UNITED STATES
ATOMIC ENERGY COMMISSION
WASHINGTON, D.C. 20545

Docket Nos. 50-280 ✓
and 50-281

Change No. 13

4.15 AUGMENTED INSERVICE INSPECTION PROGRAM FOR HIGH ENERGY LINES
OUTSIDE OF CONTAINMENT

MAIN STEAM AND FEEDWATER LINES - UNIT 2
 SURRY POWER STATION
 UNITS 1 AND 2

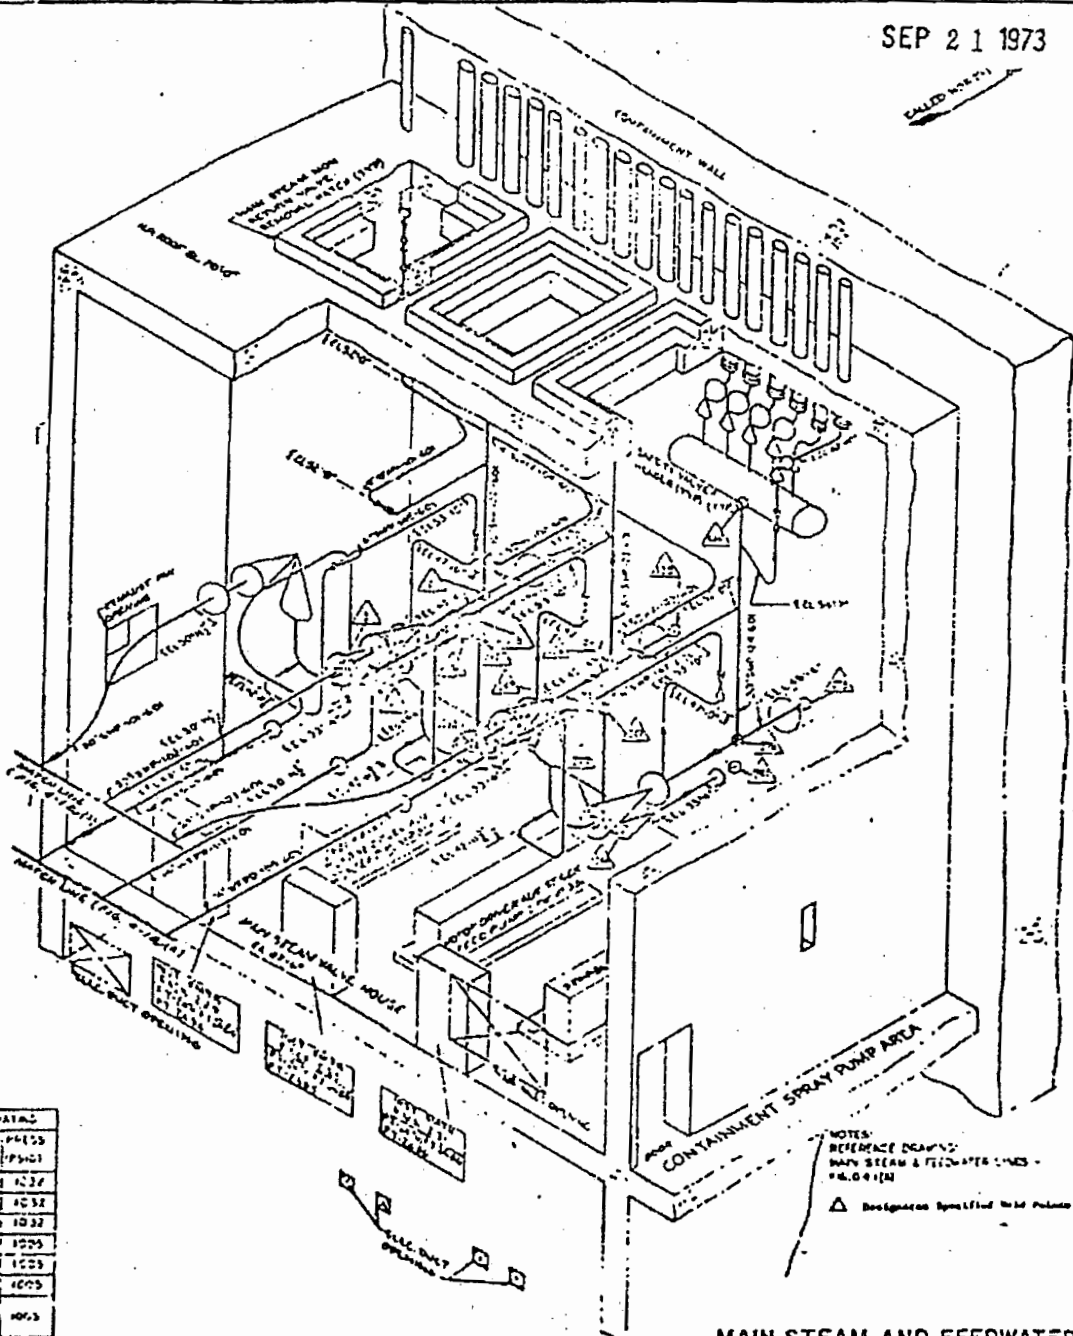
- A. For the 20 welds identified in TS Figure 4.15:
 1. At the first refueling outage period a volumetric examination shall be performed with 100 percent inspection of welds in accordance with the requirement of ASME Section XI Code, 'Inservice Inspection of Nuclear Power Plant Components, to

- B. For all welds other than those identified in TS Figure 4.15:
1. Welds in the main steam lines including the safety valve headers and in the feedwater lines in the main steam valve house shall be examined in accordance with the requirements of subsection ISC 100 through 600 of the 1972 Winter Addenda of the ASME Section XI Code.

2. The inservice inspection at each weld shall be performed in accordance with the requirements of ASME Section XI Code, Inservice Inspection of Nuclear Power Plant Components, with the following schedule: (The inspection intervals identified below sequentially follow the baseline examination of TS 4.15.A.1 above):

3. Examinations that reveal unacceptable structural defects in a weld during an inspection under TS 4.15.A.2 shall be extended to require an additional inspection of another 1/3 of the welds. If further unacceptable defects are detected in the second sampling, the remainder of the welds shall be inspected.

4. In the event repairs of any welds are required following any examination during successive inspection intervals, the inspection schedule for the repaired welds will revert back to the first 10 year inspection program.
